## PLAN COMMISSION

September 10, 2019

**Proposal:** Plan Review – Screening Modifications for Edgewood Elementary School

**Proposal:** Plan Review – Site, Landscaping, and Screening Modifications for Meadowview Elementary School

DRAWING TITLE  
**ROOF MECHANICAL PLAN**

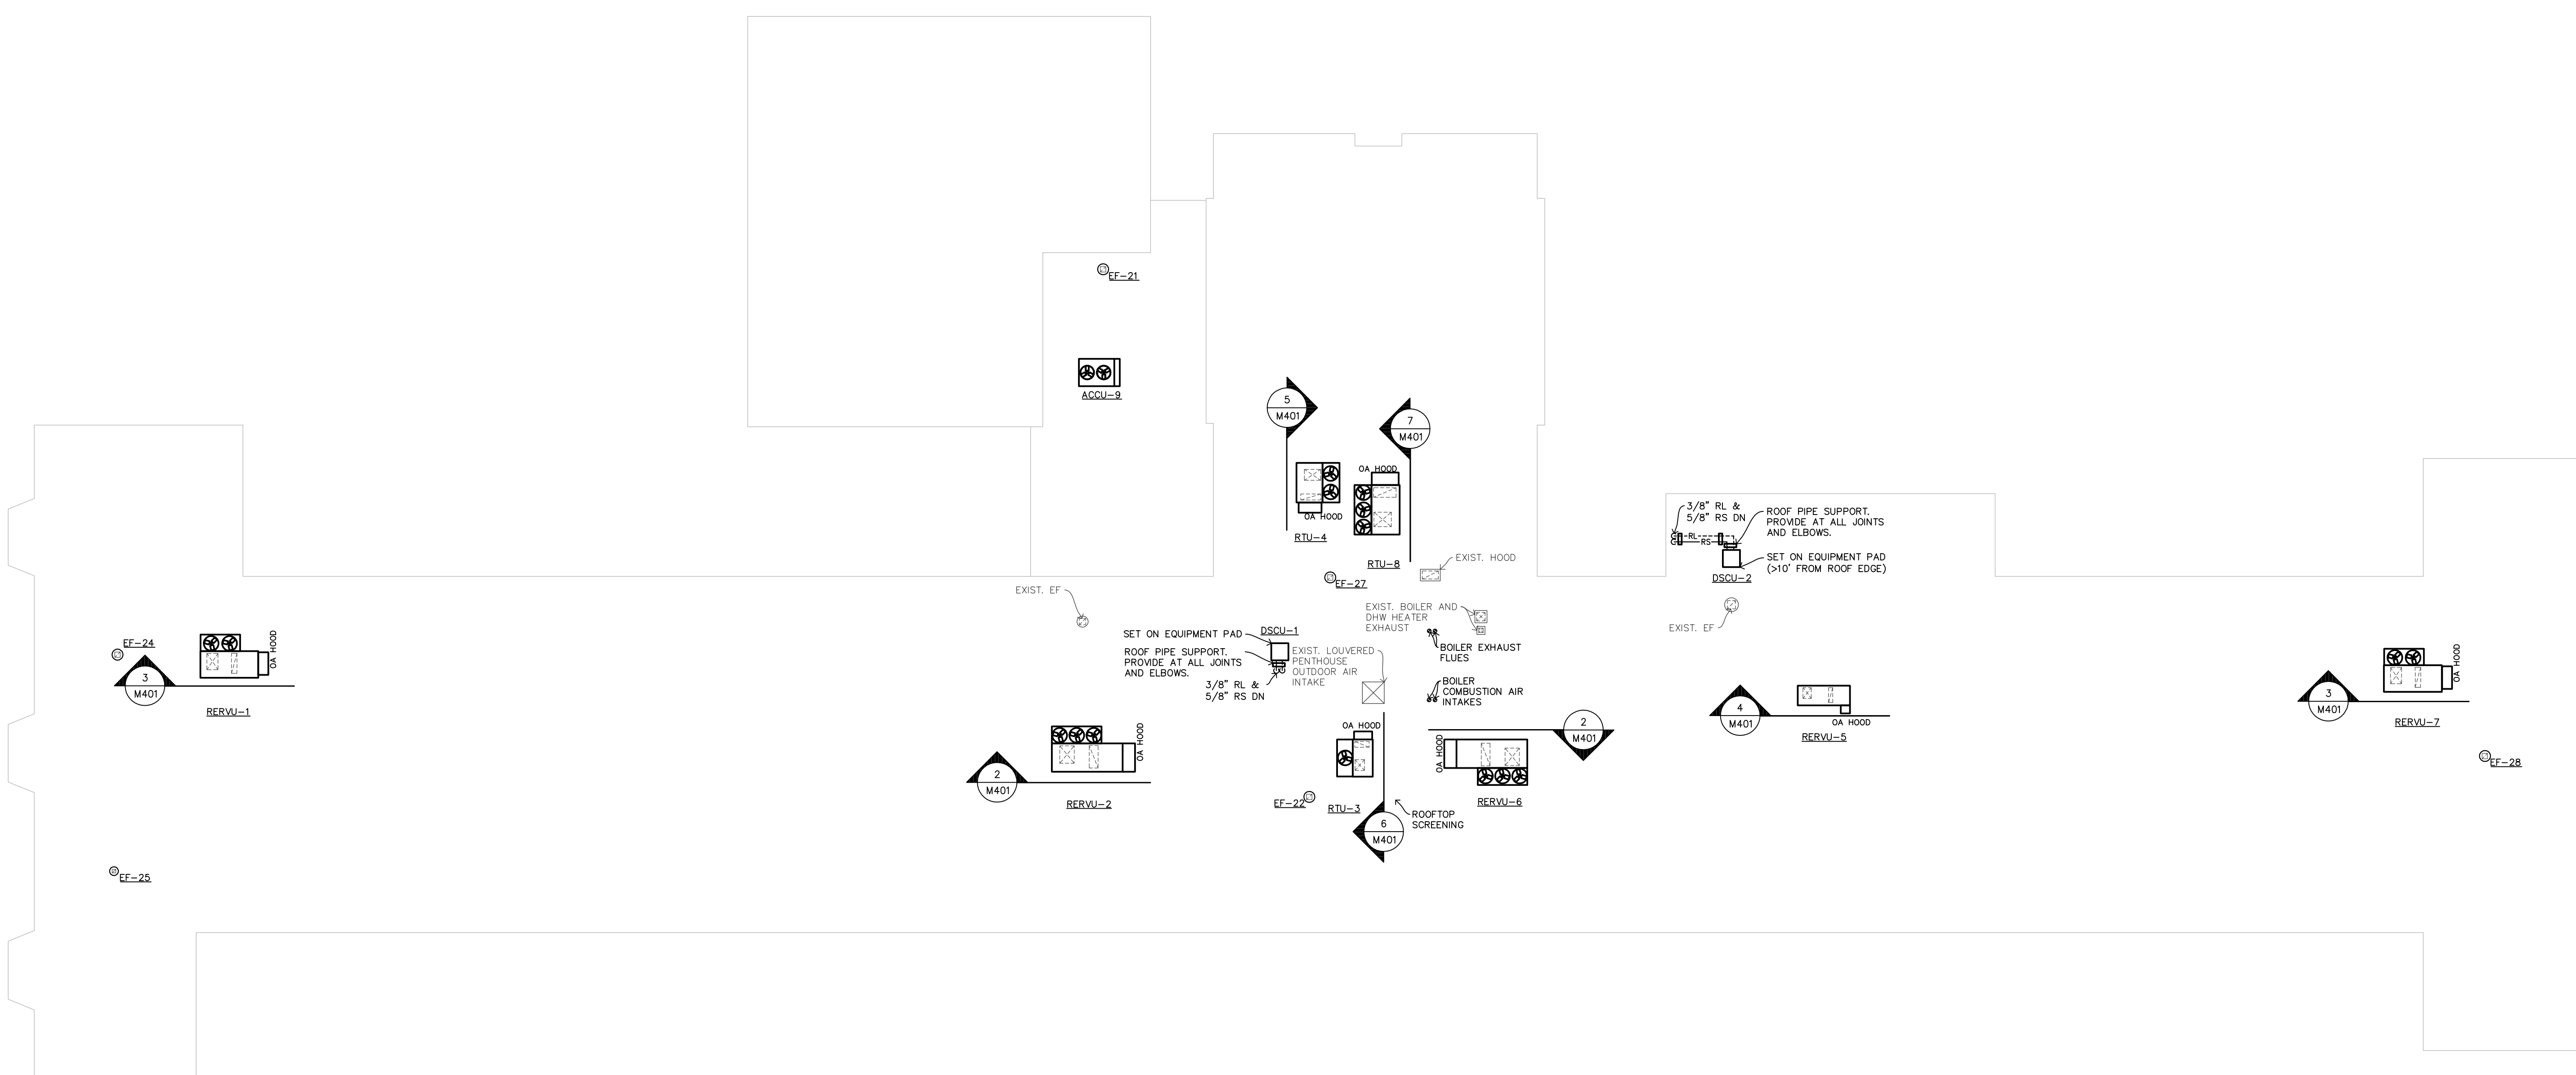
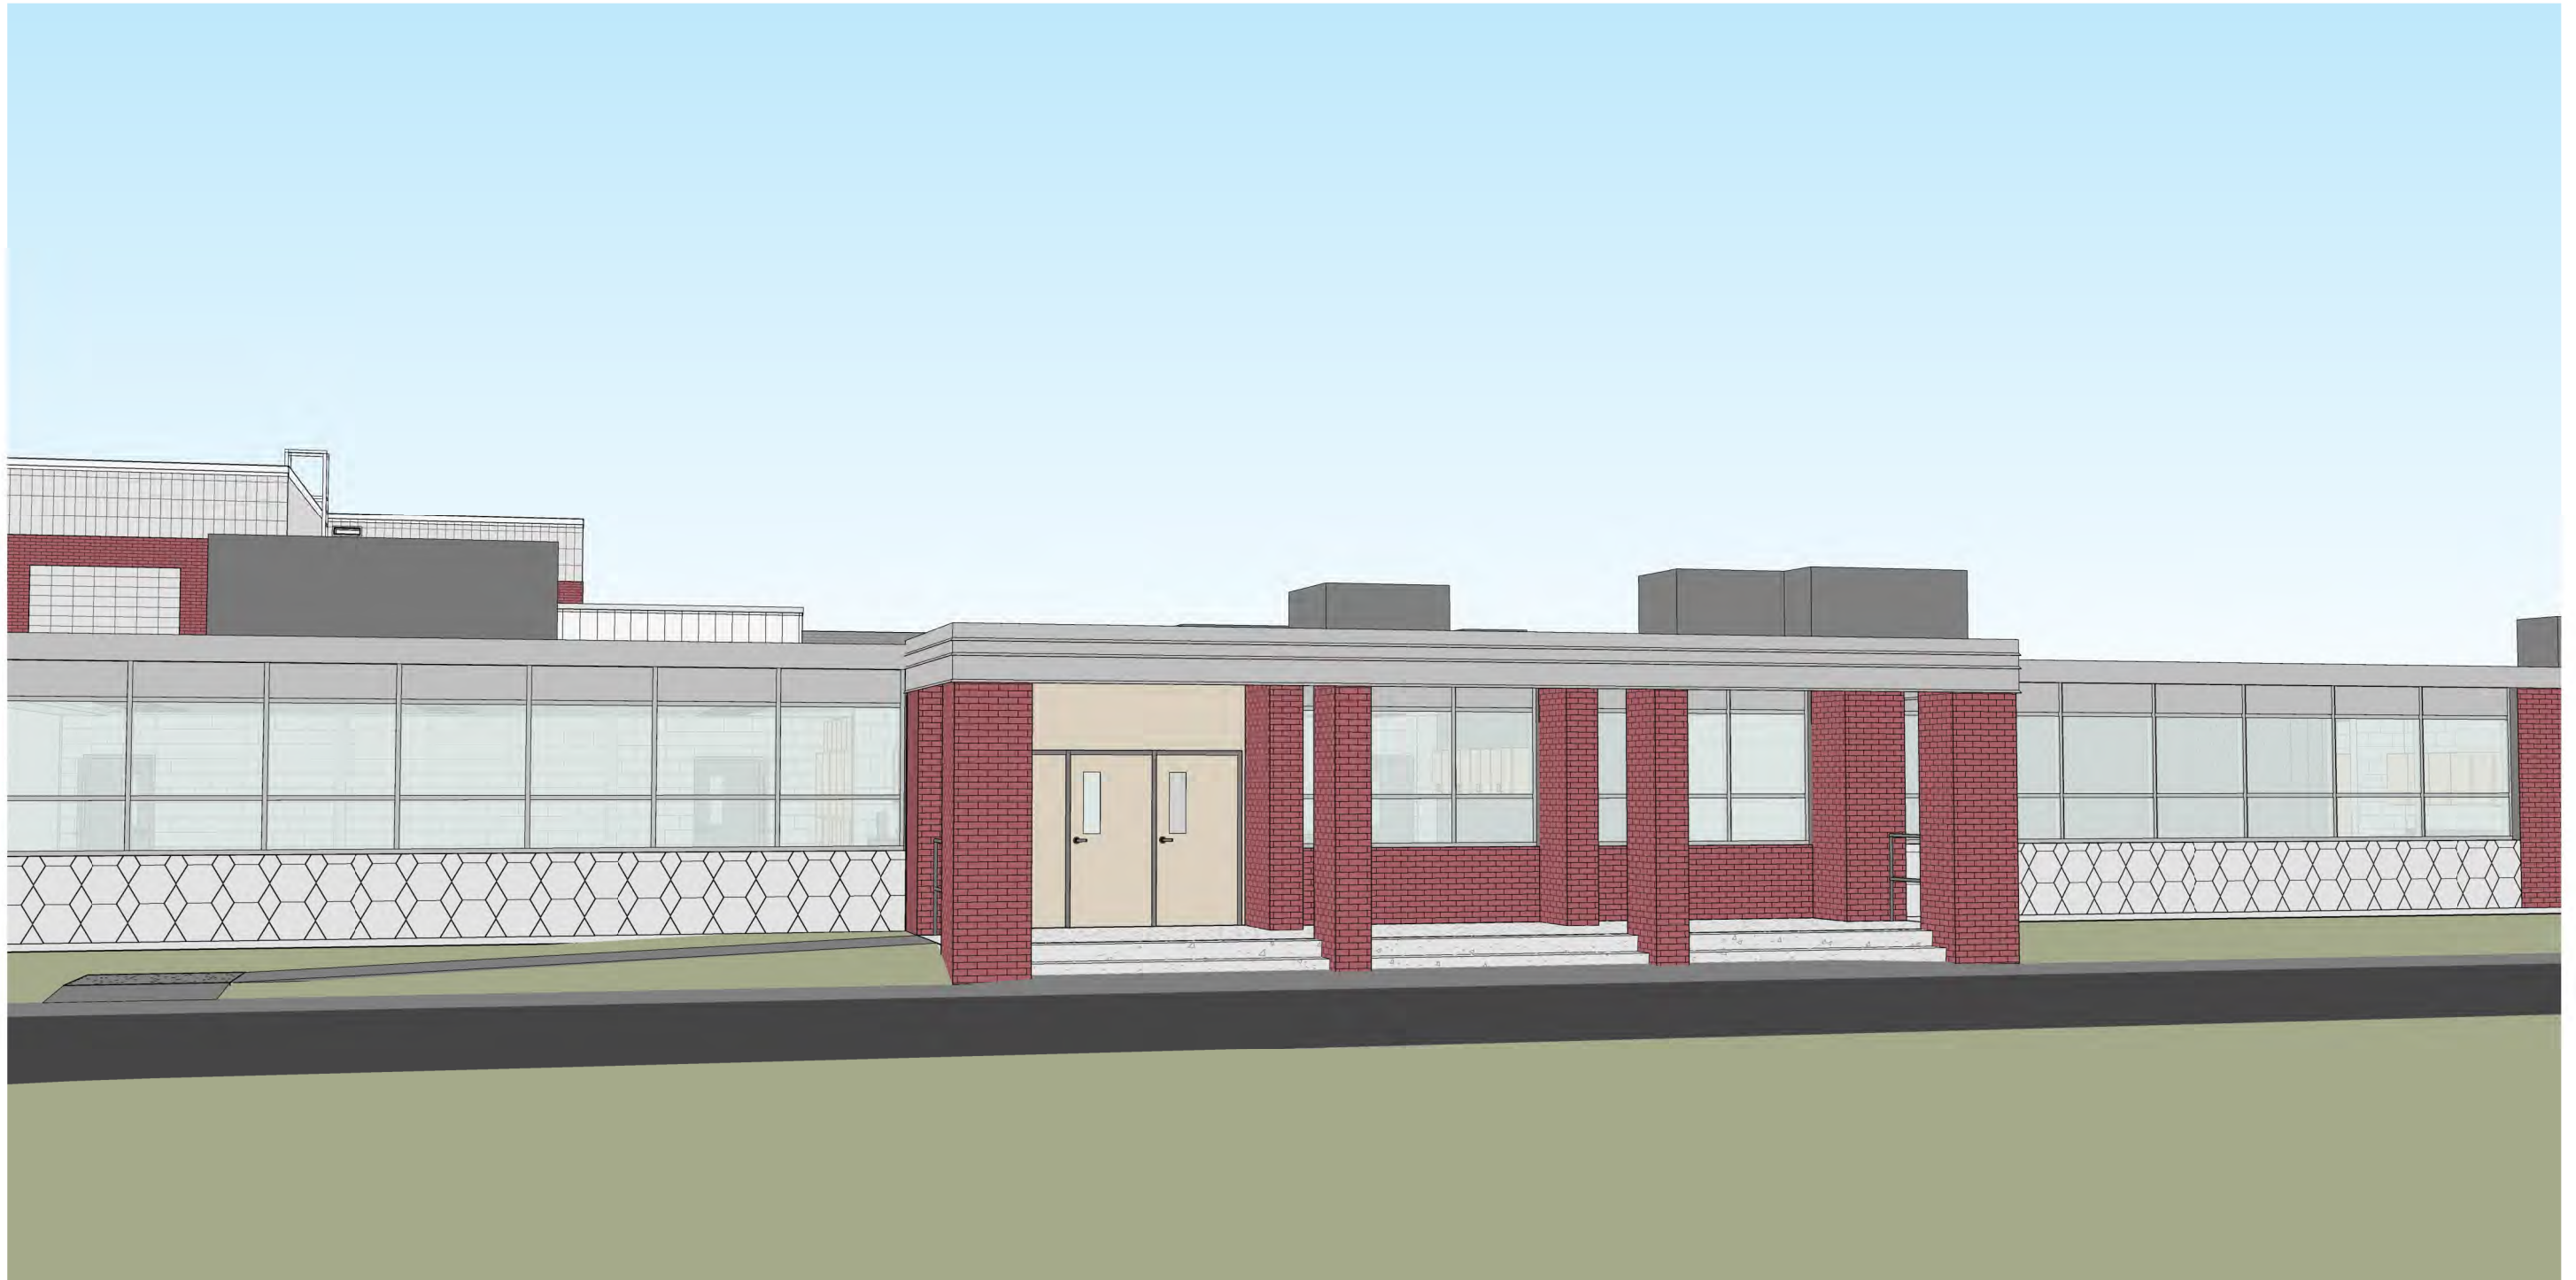
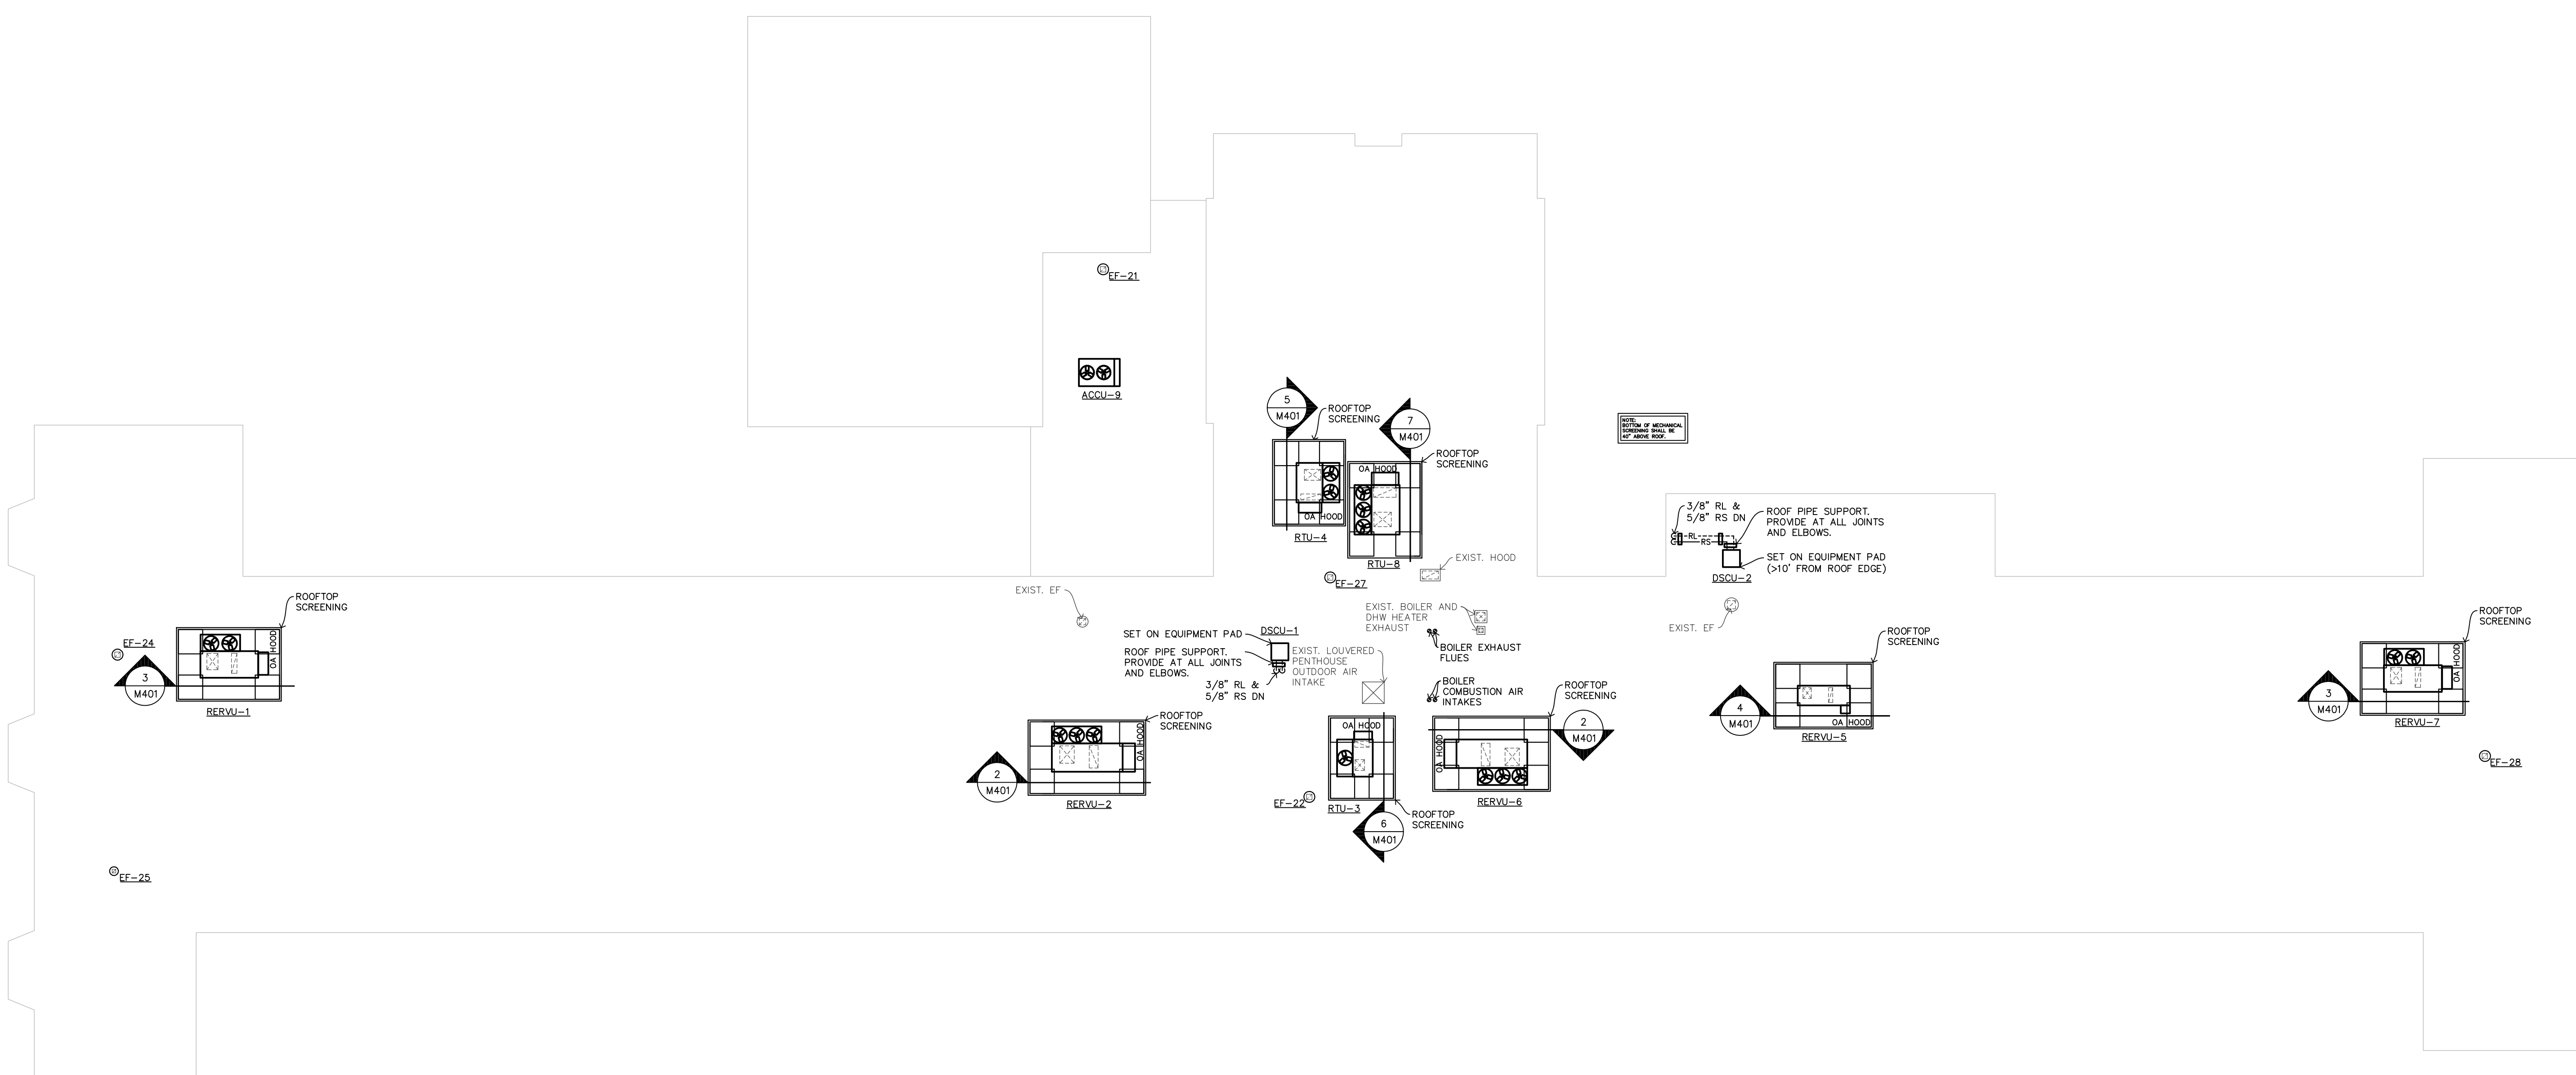
At the March 12, 2019 meeting, the Plan Commission approved site plans for modifications to the parking lot, a new access drive and parking lot, an elevator addition, and an addition for a new gymnasium for Meadowview Elementary School at 10420 S. McGraw Dr. Plan Commissioners may recall that existing rooftop mechanical units (RTUs), which are not currently screened, were to be replaced with larger RTUs. Per Section 17.1010(g) of the Municipal Code, “roof mounted mechanical equipment shall be screened from casual view.” Additionally, landscape islands within the parking lots per Sections 17.0403(g) and 17.1010(b) were required. The Applicant is requesting a modification to remove these requirements from the plans.

As mentioned in the previous staff report for Edgewood Elementary School, while staff can appreciate that the existing RTUs have not historically been screened, any change to the existing conditions requires conformance with Code. This is true for any site or building modification within the City. Staff disagrees with the assessment in the submitted narrative that screening will make the RTUs more visible from the road, and that screening will be less aesthetically pleasing than exposed RTUs. Rather, screening as included in the submitted examples and throughout the City generally have the effect of blending with the architecture of the building. Those structures that do not incorporate RTU screening are more visible from the road, and are the examples of why the Code requires screening. Staff have consistently included in Conditions of Approval for Plan Commission consideration that all mechanical equipment, transformers, and utility boxes (ground, building, and rooftop) are screened from view per Code requirements, including in this case.

- Existing RTU being replaced was: 58" w x 88" l x 50" h on top of ~12" curb.
- New RERVU is: 95" w x 128" l x 50" h on top of 14" curb. The unit is longer due to energy recovery and wider due to DX cooling module.
- With the RERVU having a housing dimension of 58" w x 128" l x 50" h (not including DX module and outdoor hood), adding screening results in: 154" w x 224" l x 50" h. Therefore the screening with add 59" of obstructed view at this unit.
- Other locations we're combining existing RTU to single RERVU or moving existing roof edge located RTU away from edge
- Adding screening to RTU's on this building will add a total of 8' of obstructed view to the roof of the building.

1. That all relevant Code requirements remain in effect.
2. That all conditions of approval from March 12, 2019 remain in effect except as specifically amended herein.
3. That the proposed rooftop mechanical units are not required to be screened at this time; however, any changes to the rooftop mechanical units will require screening at the time of installation.
4. That the three (3) landscape islands in the south parking lot are not required to be installed at this time; however, any change(s) to the parking area will require landscaping in conformance with Code requirements in effect at the time of the change(s).
5. That all detailed, revised plans are submitted in digital format to the Department of Community Development prior to submission of permit applications.
